STATE OF IDAHO
DEPARTMENT OF
ENVIRONMENTAL QUALITY

Subject: Reuse Permit No. I-010-06, Idahoan – Idaho Falls Facility, Permit Modification 2

I-010-06 – Modification 2

Complete Description of Modification

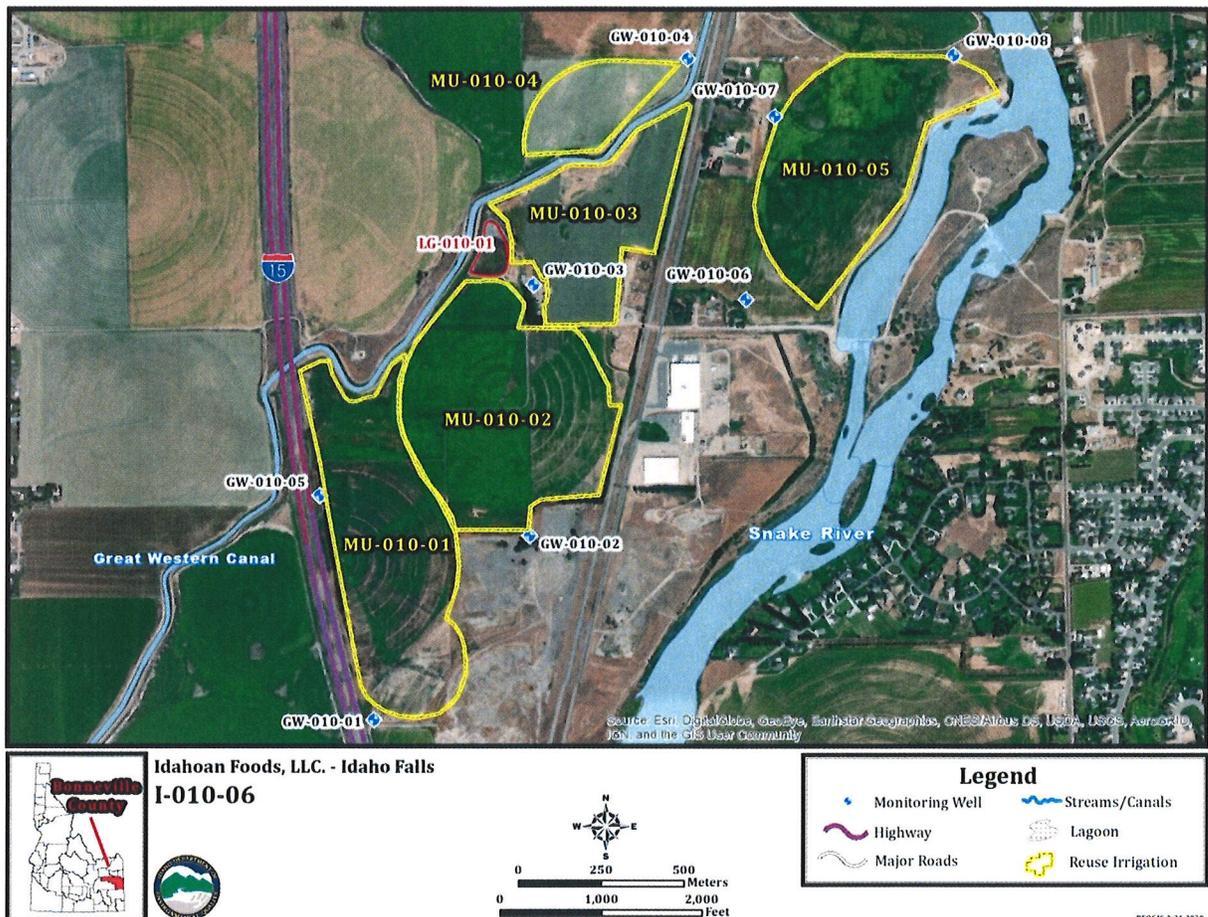
15. Section 5.4.1. Crop Harvest Monitoring, Page 19 of the Reuse Permit. Add “MU-01005” below “MU-01004” in the second row of the first column.
16. Section 5.4.2. Plant Tissue Monitoring, Page 19 of the Reuse Permit. Add “MU-01005” below “MU-01004” in the second row of the first column.
17. Section 6.1.2. Required Contents, Page 21 and 22 of the Reuse Permit. Add “MU-01005” below “MU-01004” in the second row of the first column.
18. Section 11.2. Facility Map, Page 34 of the Reuse Permit. Replace the map with the following map:
